2017 MMC Program

Mechanical Maintenance Conference

AMC Reference 17-110/MSG-338
August 31, 2017

Figure 1: Typical Installation

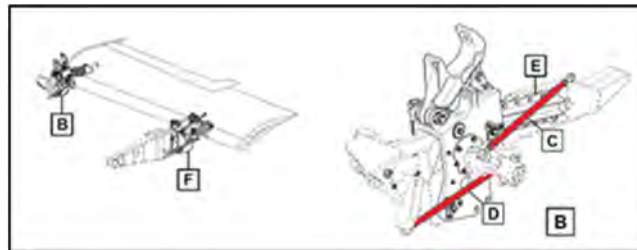
It seems the inspection works fine. We know that these components have a function as a mechanical fuse. For each defect, we are checking the condition which gives excessive load to the wing. But for now, there is nothing like hard landing, or hard turbulence.

JAL would like all the airframers to provide comments on this matter.

<u>Item</u>	<u>LRU Name</u>	<u>LRU PN</u>	<u>Vendor</u>	<u>Aircraft</u>	<u>ATA</u>	<u>From</u>
26	Elevator PCU	390600-1009	Parker	DHC-8-402Q	27	LHT

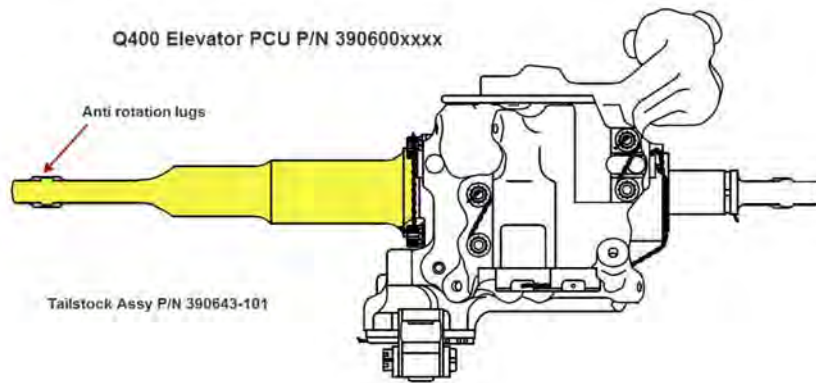
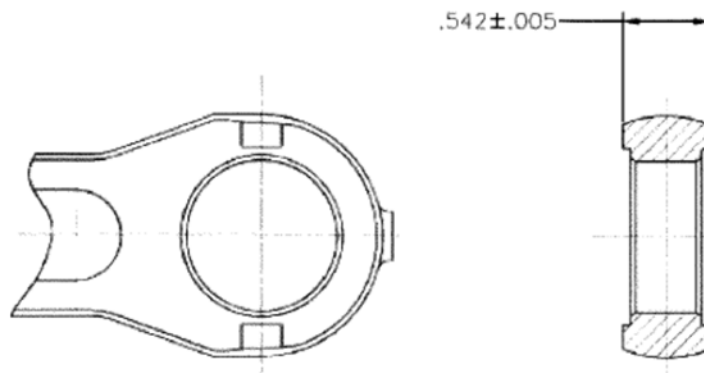
LHT experienced several cases where the anti-rotation lugs of the tailstock show some wear marks. Total Time of most of the Elevator PCUs was below 20,000 FH

Since there is no specific inspection criteria in the CMM, LHT contacted Parker about the omissions.

Parker came up with following instructions:

1. Perform visual inspection of anti-rotation lugs for scuffing, damage and measure 0.542 ± 0.005
2. Replace tail stock P/N 390643-101 if the above anti rotation lugs dimension is below 0.537 inches.

<u>Item</u>	<u>LRU Name</u>	<u>LRU PN</u>	<u>Vendor</u>	<u>Aircraft</u>	<u>ATA</u>	<u>From</u>
32	Hydraulic Accumulators	SB209L1A1	Hydac	A320	29	LHT

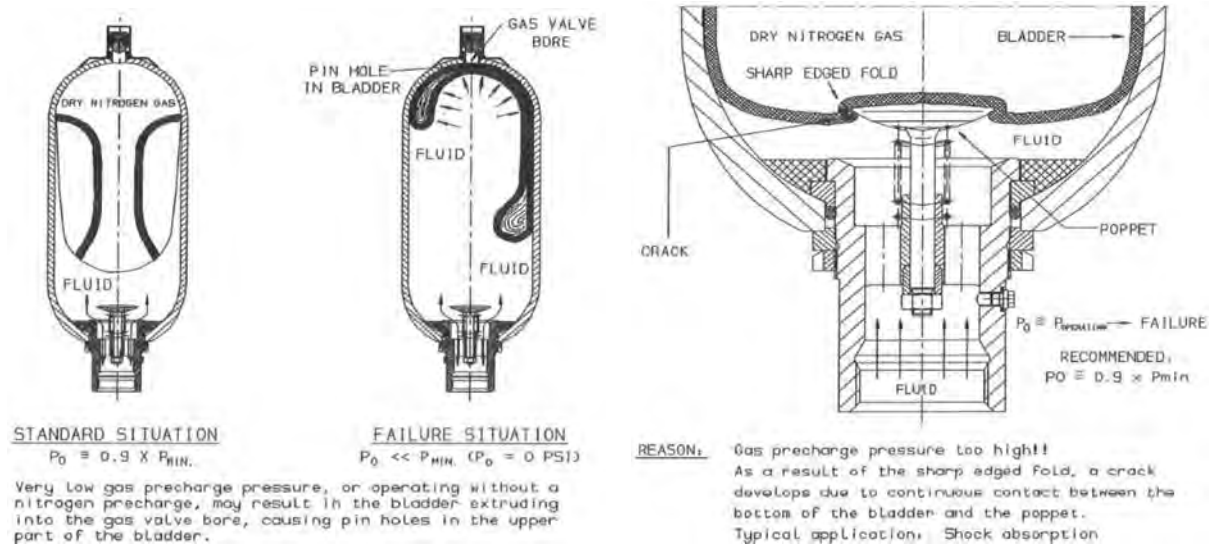
LHT frequently receives hydraulic accumulators from service with damaged bladders. Hydac claims those damages being a result of either under or overfilling situation as shown in the figures below and therefore rejects warranty adjudication, even if the accumulator is with in warranty period. Operators on the other side can prove that all maintenance interval acc. to AMM were met and reject abnormal wear and tear.

Other MROs, Hydac, and Airbus please comment if those damages are considered damages due to normal operation or abnormal wear and tear. Please also comment if the present maintenance intervals are considered sufficient.

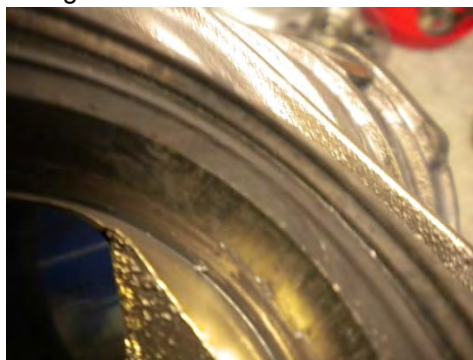
Problems of vibration on engine CF6-80E1, which causes heavy damages on HP REGULATING VALVE and ANTI ICE PNEUMATIC SHUTOFF VALVE. The vibrations seem to continue despite the modification by addition of links (VSB GE CF6-80E1 72-0472 and AIB A330-71-3029).

Will AIB, GE or LBH, and UTAS provide a new solution to improve the reliability of both components?

PN TY1540-20 – SN 1855

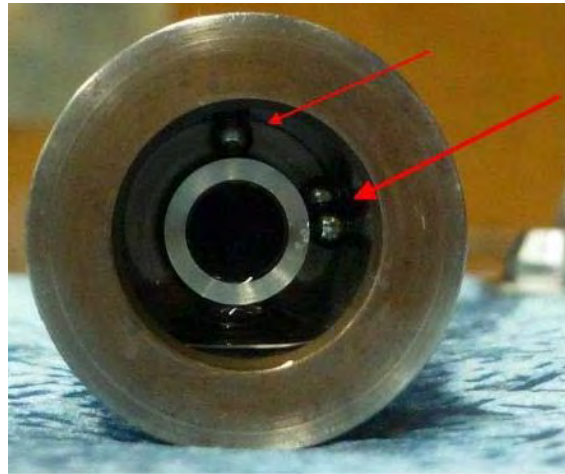
LHT frequently receives Hydraulic Control Units P/N TY1540-Series and Lower Locking Actuator P/N TY1542 from Engine V2500 with loose balls inside resulting from ball bearing IPL Item 2-280 inside the actuator.

Other MROs and OEMs, please comment on the evaluation that this situation is considered abnormal wear and tear. Is it possible to identify a root cause? OEMs please comment.

<u>Item</u>	<u>LRU Name</u>	<u>LRU PN</u>	<u>Vendor</u>	<u>Aircraft</u>	<u>ATA</u>	<u>From</u>	<u>If MRO, the Associate Airline</u>
87	Manual Selector Valve	S4-3400900-01 1567A0000-01	Liebherr	A320 Fam	52-30-13 52-30-16	LHT	DLH

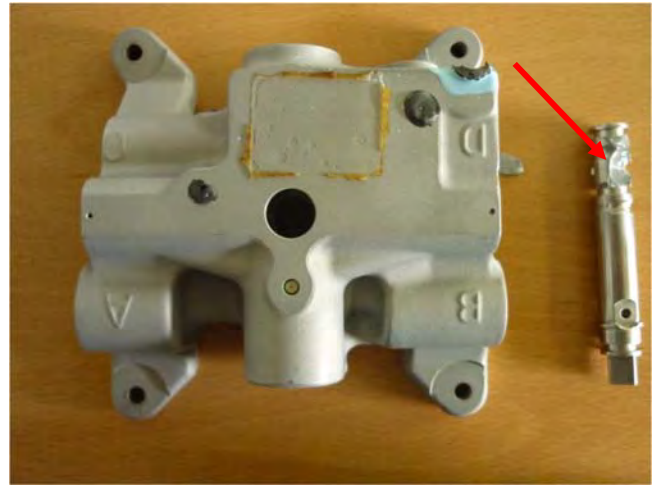
LHT frequently receives units with broken/sheared flange. OEM refers to such cases as mishandling. Operators confirm normal use of manual selector valve handle in service. Until today, only TFU REF: 52.36.00.008 and A/C SB A320-52-1160 are in place, but no component VSB has been issued.

Question:
Is this problem known to other operators/MROs?

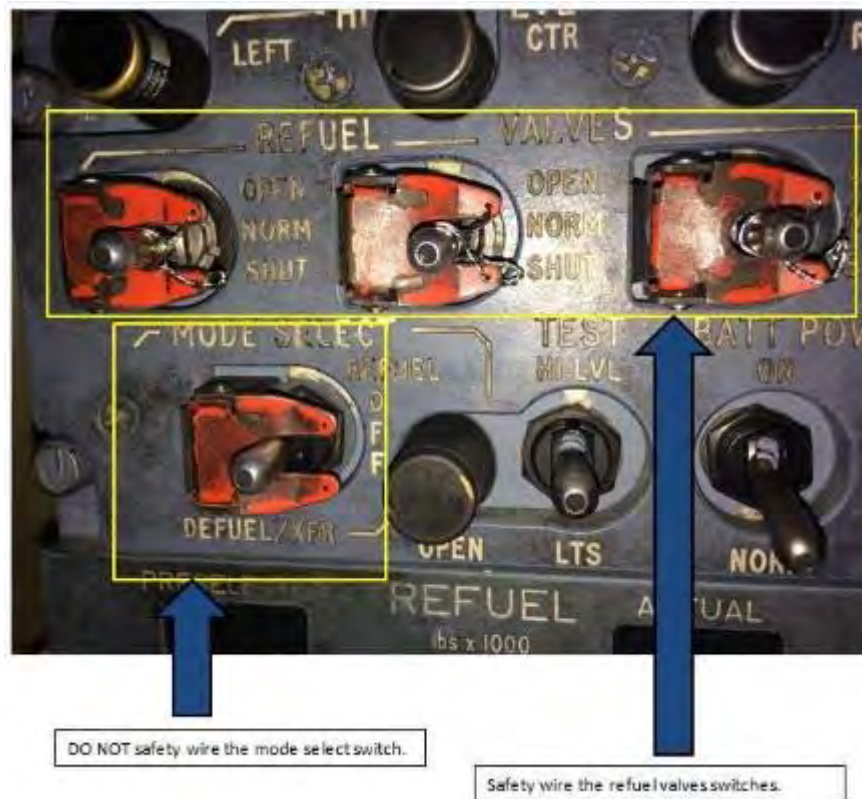
Several reports of fuel distribution errors during A320 aircraft refueling have been brought to engineering's attention. Airbus' recommended method of refueling is the AUTOMATIC mode; however, station visits and refueling observations reveal fueling being conducted manually or using Manual mode.

1. Are any other operators experiencing refueling inaccuracies/issue during refueling in AUTO mode?
2. How are operators ensuring the 3rd party vendors (refueling) use the AUTO mode?
3. Are there any mods or means that operators have used to encourage AUTO refueling (example: installation of safety wires on refuel valve switches)? If yes, then how were the results post mod?

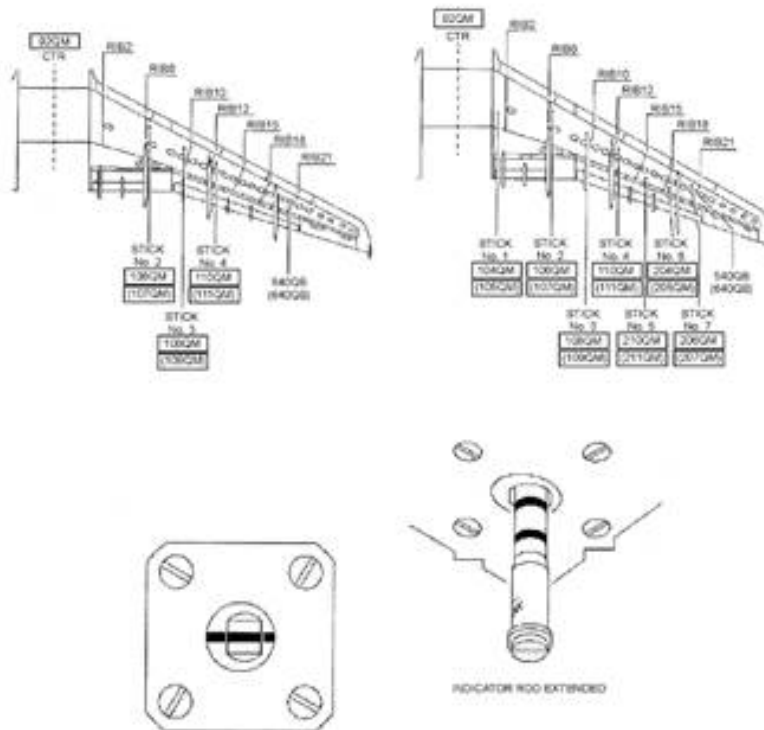
However, some new aircraft have only 3 MLIs but require operators to use the previously provided 7 MLI chart. This is confusing as with the reduction in MLI quantities, with the 3 MLI A321 aircraft, the maximum fuel quantity that one could obtain through MLI charts is 1847 gallons. Note: the full tank capacity of A321 is 2050 gallons (Difference of approximate 200 gallons).

1. How is an operator to read a fuel quantity using MLI and the charts provided when the fuel uploaded on A321 aircrafts wing tank is between 1847 and 2050 gallons on an A321 aircraft?
2. Can Airbus provide a corresponding 3 MLI chart for aircraft that have only 3 MLIs installed?

Interruption Rate (SR) - Chargeable - L12M (Ref. Date: 01/2016) - EJETS WORLDWIDE

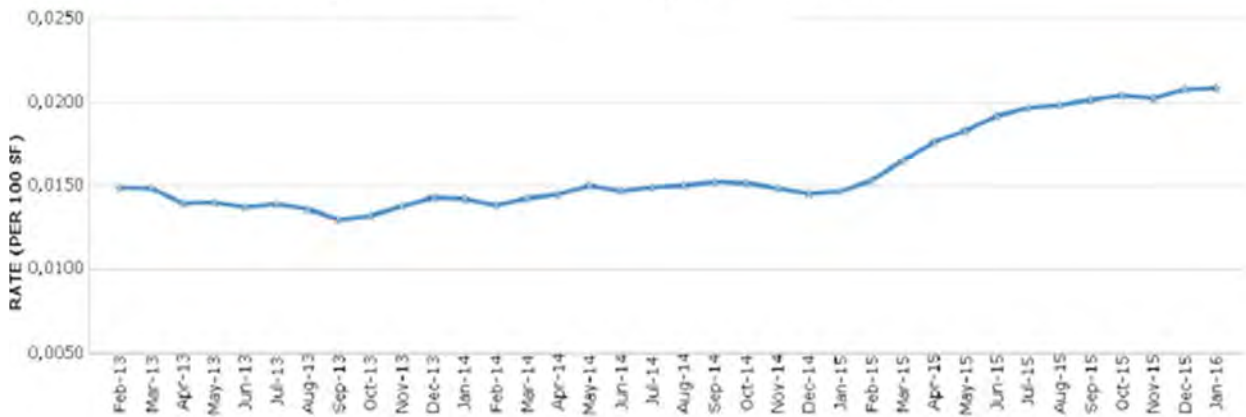
Since entry into service at American Airlines, the Nose Wheel Steering Control Module (NSWCM) and its associated steer fail fault have been a reliability issue. Upgrades over the years have provided a reduction in steer fail faults as well as provided the ability to reset off gate (resets help move the aircraft, but are not the real fix). While these upgrades have had a positive impact in delays and cancellations, the rate is still an issue at AAL and other operators.

The chart above from Embraer highlights the increase in EJETS worldwide since February 2013 and the increase in February 2015. Despite the improvements in the NSWCM software, AA and other operators are still experiencing reliability issues.

Photo 1: Cylinder Barrel Outer Surface Under the ID Plate (ID Plate Removed)

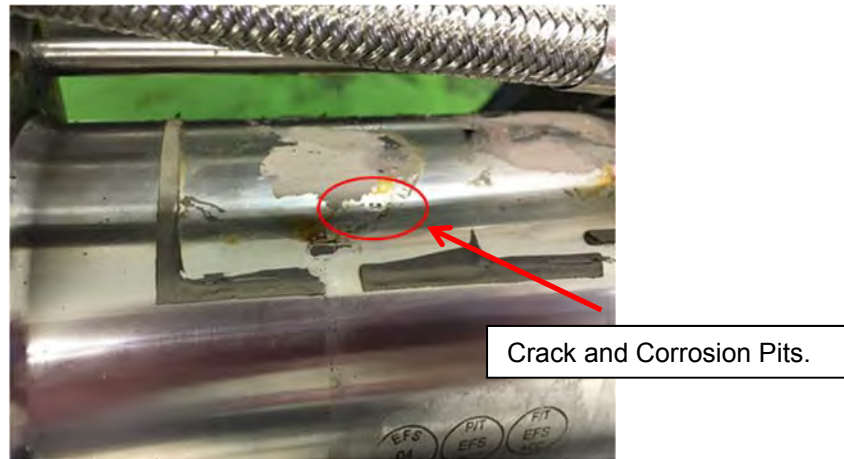
We have experienced several cases of crack on the Cylinder Barrel outer surface under the ID Plate. The crack caused hydraulic fluid leakage and flight dispatch delay/cancel. The cracked Cylinder Barrel was investigated at Boeing, and we had been notified that the root cause of crack was that the cracks were generated as a result of corrosion-related pitting on the outer surface of the Cylinder Barrel. Boeing also informed us that Boeing believes the corrosion pit under the ID plate issues are not a B737NG fleet-wide issue. However, we already experienced six cases of crack on the Cylinder Barrel outer surface under the ID Plate in MLG Retract Actuator Assy, 273A2101-101, since 2015, as below. We would like to know other operator's experience of crack on the Cylinder Barrel outer surface under the ID Plate.

Figure 1 – TITEFLEX Damaged Hose

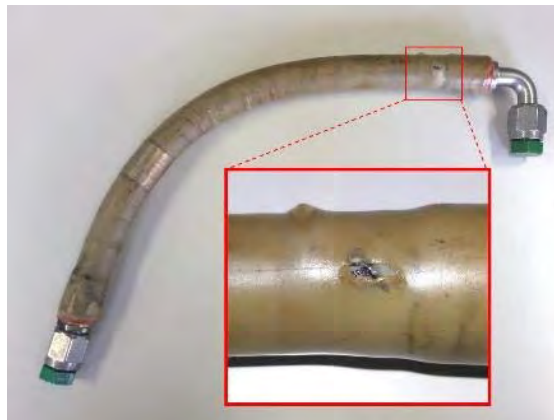
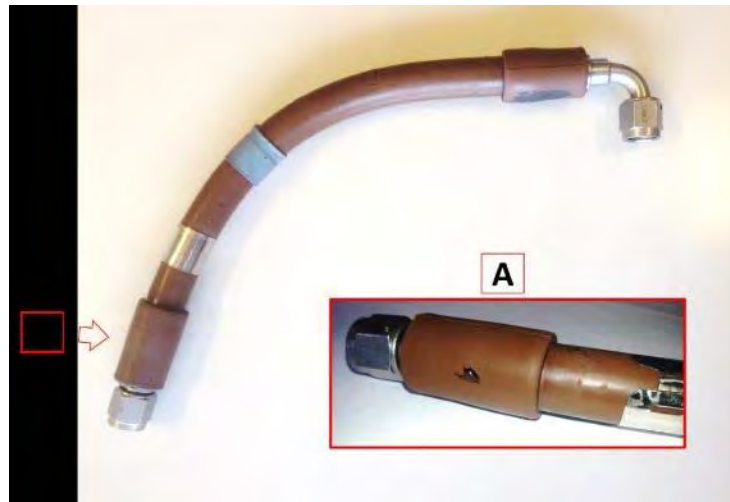
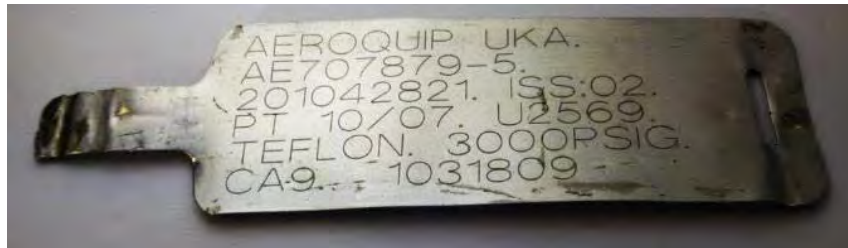
Note: Please see attached figures.

Safran and other operator comments, please.

<u>Item</u>	<u>LRU Name</u>	<u>LRU PN</u>	<u>Vendor</u>	<u>Aircraft</u>	<u>ATA</u>	<u>From</u>
129	Air Separation Module (ASM)	2060017-101 2060017-102 2060017-103	Parker	A320 FAM	47	DAL

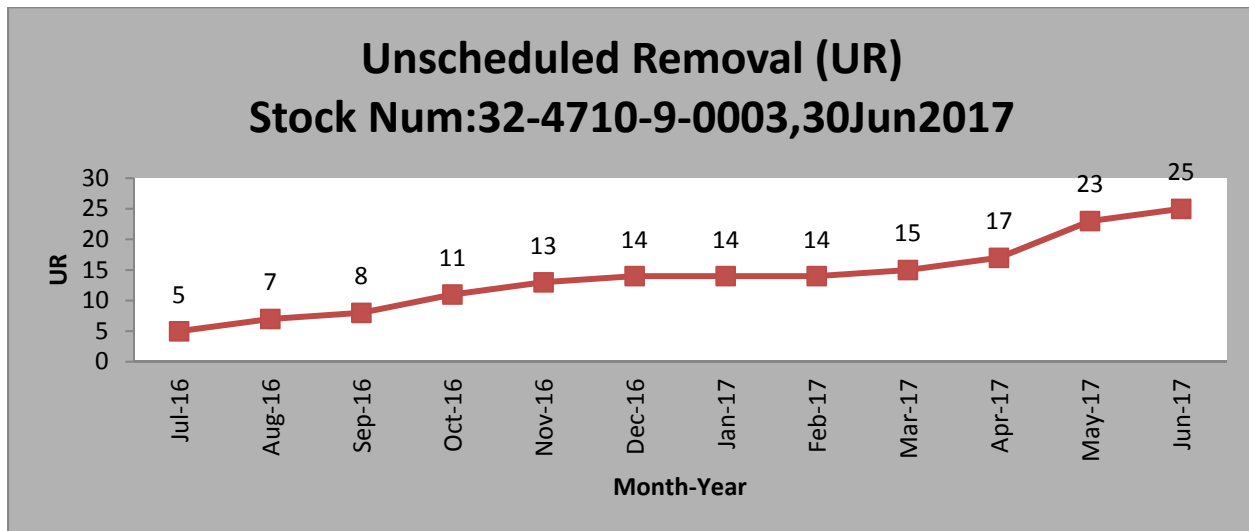
Delta has seen 30 removals in the last 18 months, for Fuel Inerting system maintenance messages and other faults. This is trending in a similar way to the B737NG Air Separation Module (ASM).

Other supplier and operator comments, please.
